BOARD OF WATER SUPPLY

Subject: Board of Water Supply (BWS) Comments to the Monitoring Well
Installation Work Plan, Red Hill Bulk Fuel Storage Facility

The BWS and its consultants have reviewed the document titled "Monitoring Well Installation Work Plan, Red Hill Bulk Fuel Storage Facility" (MWIWP) dated 29 April 2016 as discussed at the Tuesday 10 May 2016 meeting concerning the Administrative Order on Consent (AOC) work plans for Statement of Work (SOW) Sections 6 and 7. The BWS provides the following comments and recommendations to the draft MWIWP with the goal of ensuring that all work conducted under the final document will produce defensible scientific and engineering results needed to continue to protect our drinking water supplies.

Figure 1
 Geologic Cross-Section Through Halawa Valley from Wentworth (1942)

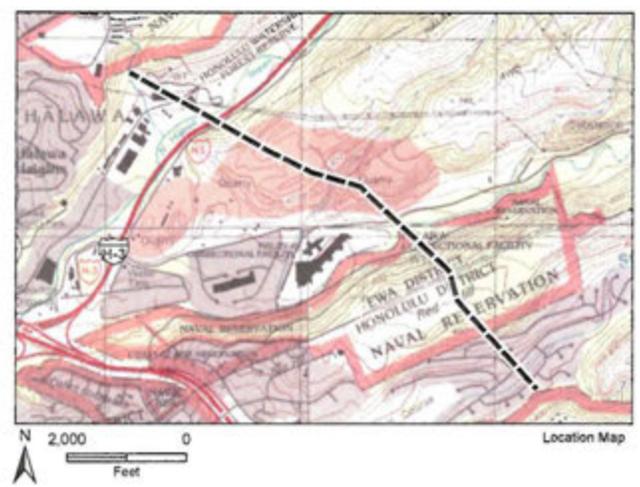
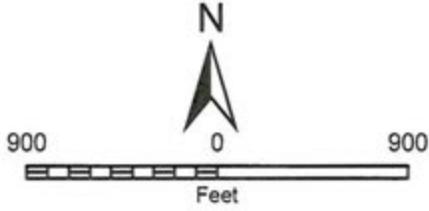
- 1) Figure 3 depictions of the assumed width and depth of the valley fill and saprolite in the North and South Halawa valleys do not take into account all available data; thus are misleading and could lead to incorrect choices for proposed well locations. Even if the authors of the MWIWP had relied only on Sherrod et al. (2007) or Stearns (1939), the depicted widths of Halawa valley fills are exaggerated by at least 50% beyond those sources. A brief physical visit to South Halawa valley will reveal that deep valley fill (greater than 50 feet in thickness) is confined only to the eastern branch of South Halawa Stream and does not extend to the western branch. The depicted depths of valley fill and saprolite also appear exaggerated and Figure 3 should be revised to reflect Plate 1 of Izuka (1992) and Figure 25 in Wentworth (1942). The enclosed Figure 1 to this letter reproduces the relevant part of Wentworth's Figure 25, which shows two end members, A and B, for the depth of valley fill in the two valleys. Only one deep well (CWRM Deep Monitoring Well HDMW2253-03) has been installed in this area of Halawa valley since Wentworth (1942) and this well appears to intersect the eastern part of the South Halawa valley fill.

Figure 2
Suggested Alternative Location for RHMW09

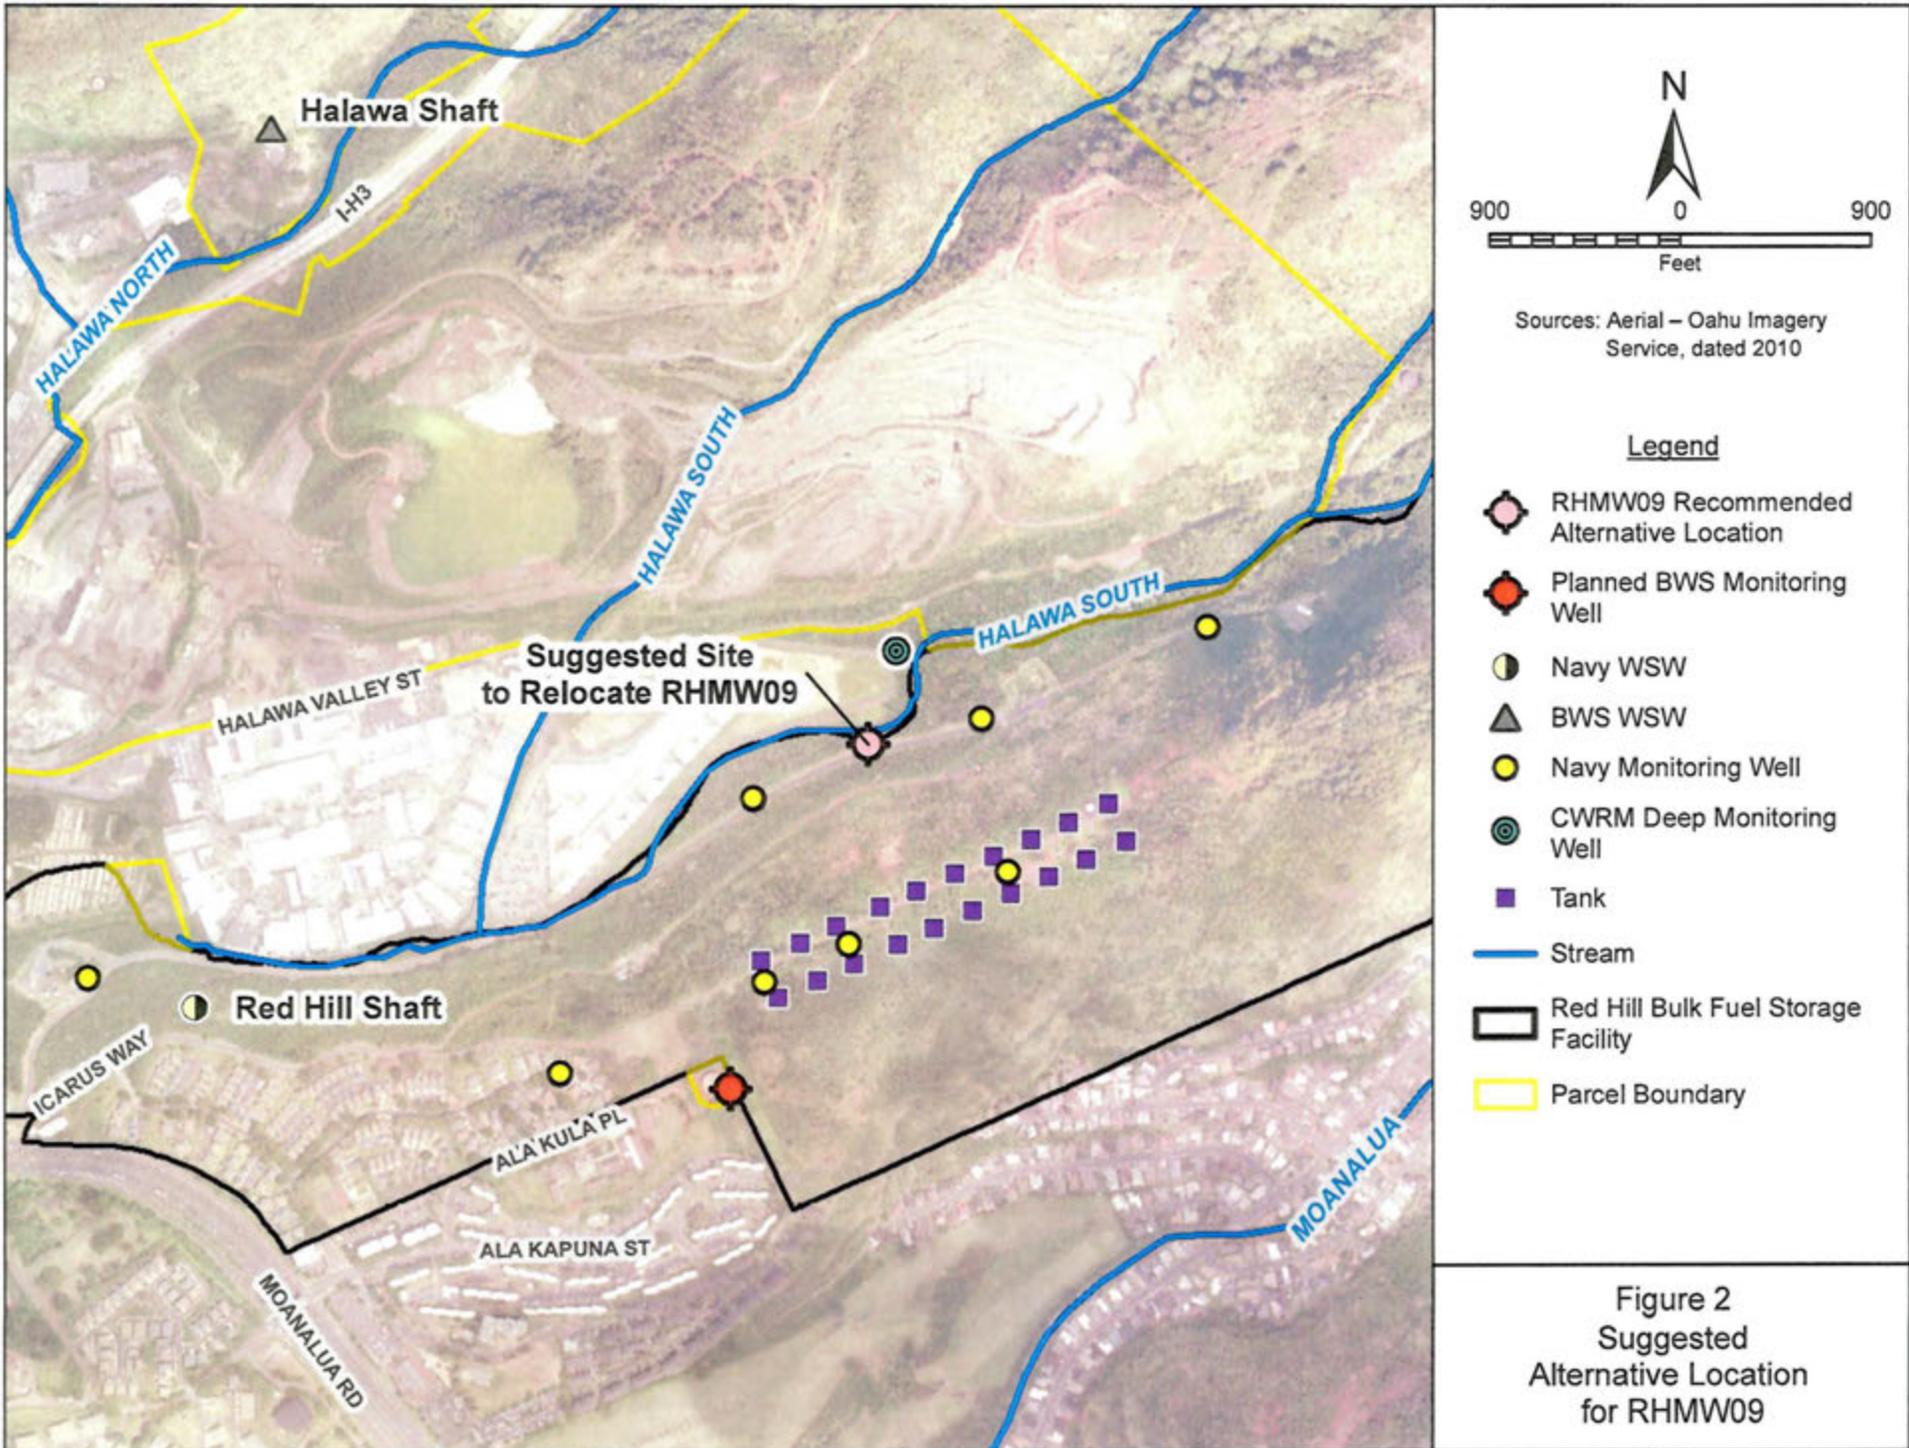
- 2) The proposed monitoring well Red Hill Monitoring Well (RHMW) 09 location is in very close proximity to a monitoring well being planned to be installed by the BWS. We recommend re-locating RHMW09 to the south side of Halawa Valley, along South Halawa stream, within the Red Hill Bulk Fuel facility boundary, such as the location shown in the enclosed Figure 2.
